## NONCOMPLIANCE INFORMATION REPORT

Van Hool N.V. has determined that a noncompliance with S5.1 of Federal Motor Vehicle Safety Standard No. 217 may exist in certain Model Year 2000 and 2001 Van Hool commuter coaches manufactured between September 1999 and September 2000. The potential noncompliance results from a possible mismatch between components of the emergency window latching system of certain Van Hool coaches.

# SERVICE BULLETIN No.P329

<b>COACH BUS MODEL</b>	: C2045
<b>BULLETIN TYPE</b>	: Safety Recall Program – NHTSA campaign number
<b>MANUAL &amp; SECTION</b>	: Maintenance Manual: Chapter 11 – Body and accessories Spare Parts Manual: Section 733409 – Windows: accessories
<b>MANUAL REVISION</b>	: No
<b>DATE</b>	: March 29th, 2005
<b>SUBJECT</b>	: <b>Passenger window catches - inspection</b>
<b>TERMS &amp; CONDITIONS</b>	: Refer to the Customer Notification Letter, which has been attached to this Bulletin.

**Figure 2: Single leaf catch type should be replaced**

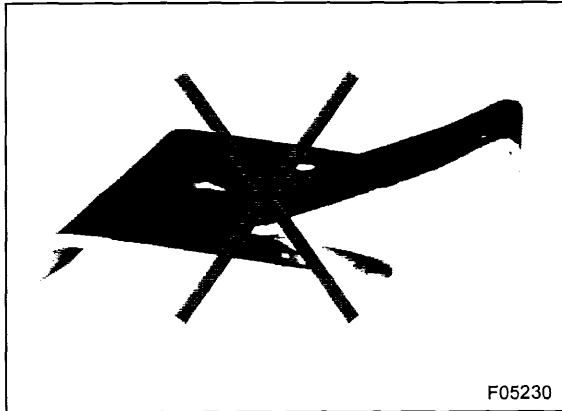
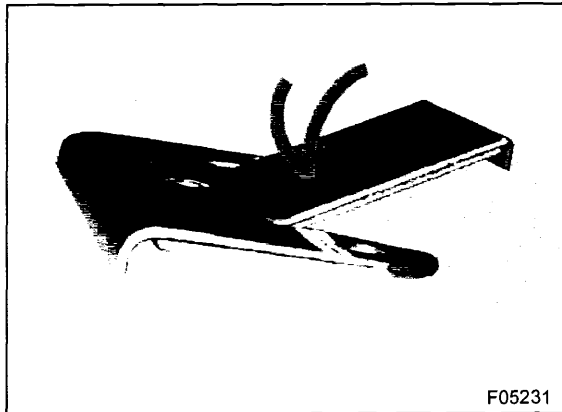
- 2) Identify the type of catch (see Figures 2 and 3), which have been attached to the bottom channel of the window frame. All single leaf catch types should be replaced.

**Figure 3: Twin leaf catch type should replace single leaf type**

- 3) If a wrong type catch has been installed, remove the old one and install a twin leaf type referring to Figures 4 and 5.

**Figure 6: Checking the emergency window handle pulling force**

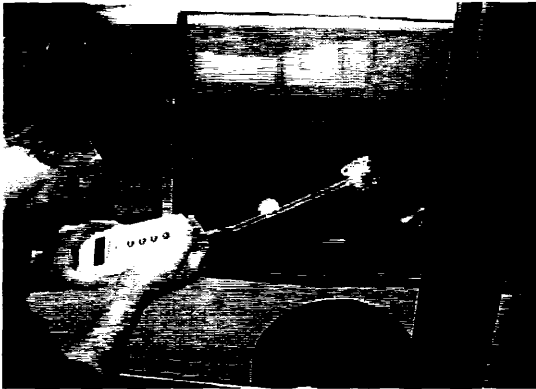
- 1) Using precision spring scales, measure the force required to pull the emergency exit handle to open the window as shown in Figure 6.  
Maximum allowable force required: 20 lbf (90N).
